Service Letter

NUMBER: 20-103

SUBJECT: Modification of Instrument Panel & Manifold Pressure System

MODELS AFFECTED: M20C, Serial Numbers 1852, 1940 through 2575
M20D, Serial Numbers 1, 101 through 190

TY-27 Nylon Straps (2)
Joints Between Instruments as Shown

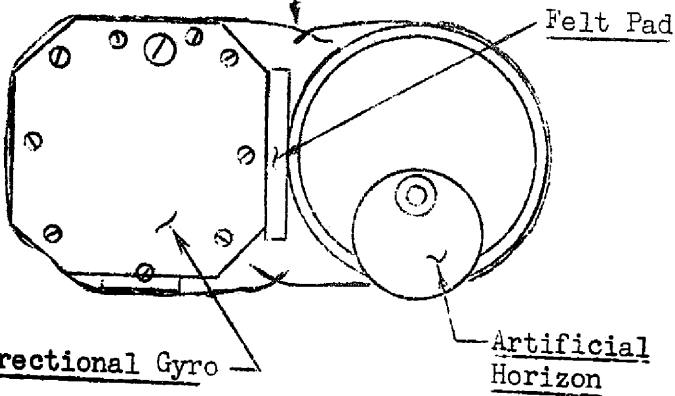
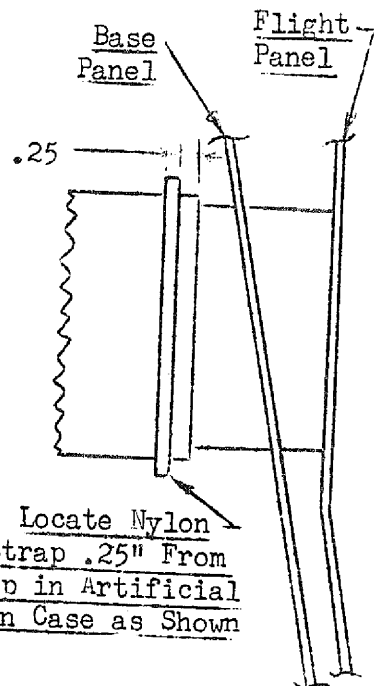
6. Included in the service letter kit are two nylon straps and one felt pad. Install the pad between the directional gyro and the artificial horizon instrument cases and secure the two instruments together as shown in Detail D on Page 2 (located on Page 2 top).

DETAIL A
 This Sheet May be Used as a Template

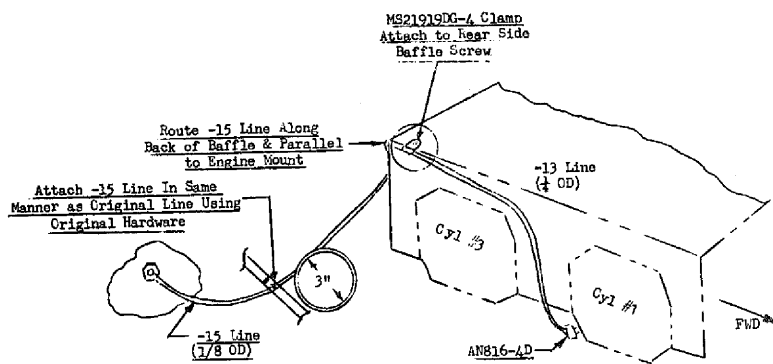
1. Remove the flight panel from the aircraft.
- *2. Modify the base panel cutout as indicated on Page 3, Detail A (located on Page 2 top).
- *3. Modify the flight panel as shown on Page 2, Detail B (located on Page 2 top).

DETAIL E

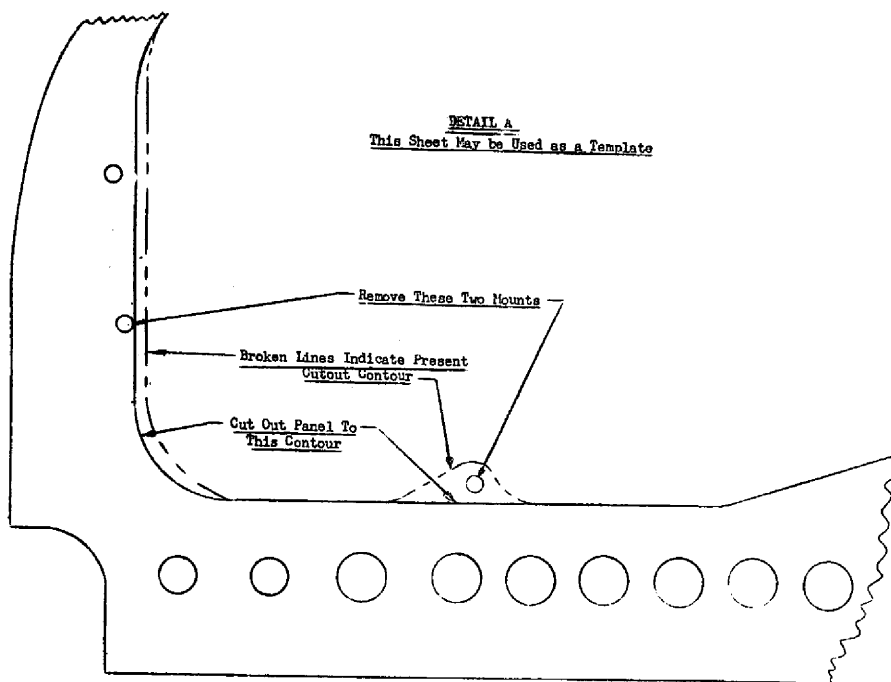
9. Install parts Numbers 660000-13 and -15 lines as shown in Detail E on Page 4. Replace the side cowl.
